**Subject:** RE: O8W-PM 35217268, 35224712, 35224713 - Bucks Creek 1101 Phase 1,2&3 -  
Pre-Engineering Meeting

# Bucks Creek 1101- PM# 35217268 Overview Map

Subject: O8W-PM 35217268, 35224712, 35224713 - Bucks Creek 1101 Phase 1,2&3 - Pre-Engineering Meeting

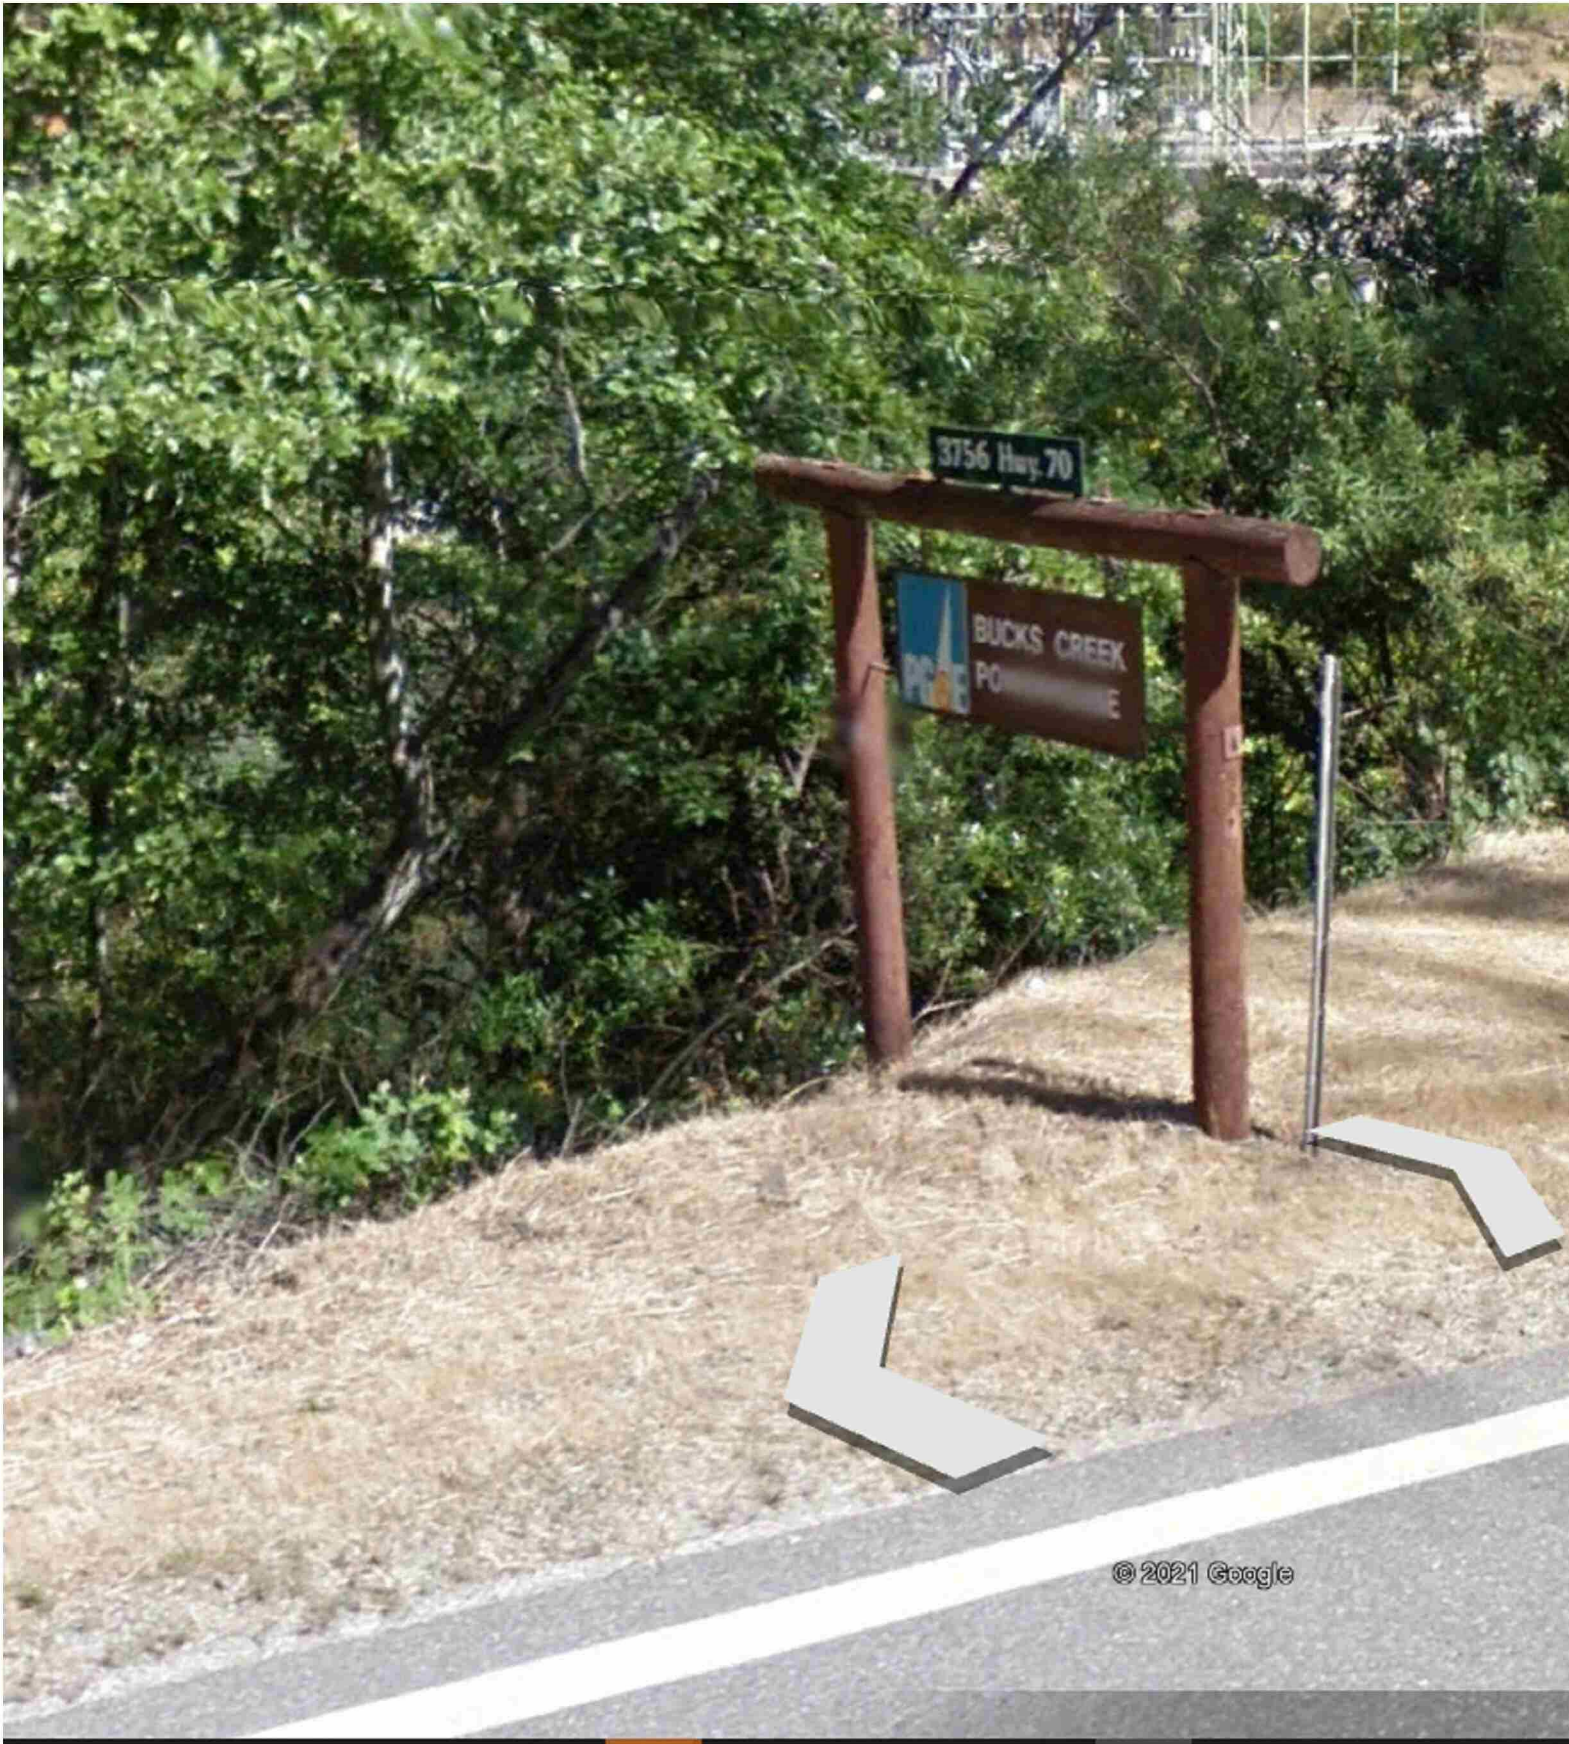
Attached are the 'base-map' limits in a kmz. file. As you will see, we need our base-map to go about ~100' into the tunnel at the south end (see pedestal in picture below....please begin about ~50 beyond this point which is about ~100' beyond the Cresta Dam).

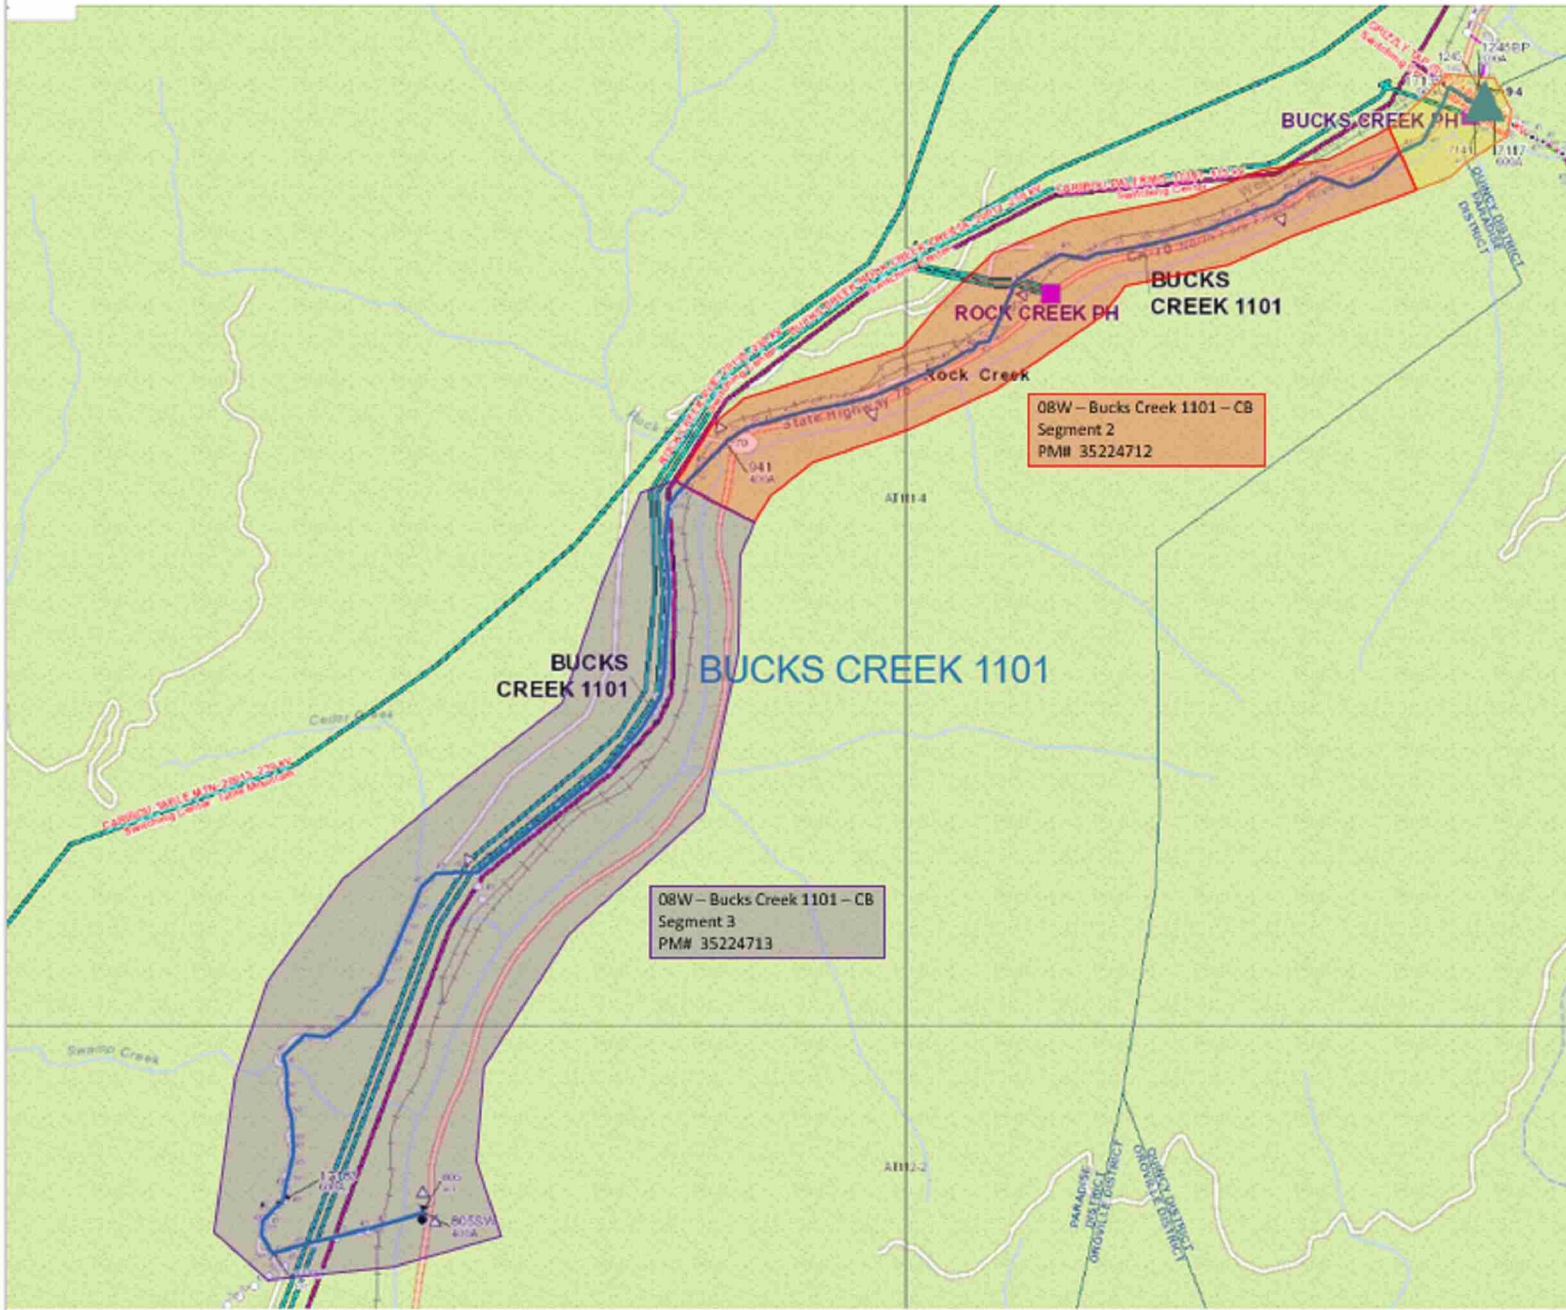
For Bucks Creek there is quite a bit of work surrounding Hwy 70 and we will need a Land Department Base Maps prepared for all 3 Orders. This will delay the EOD dates until these can be developed and provided to the Vendor... We will also need answers to the questions outlined by [REDACTED] below...
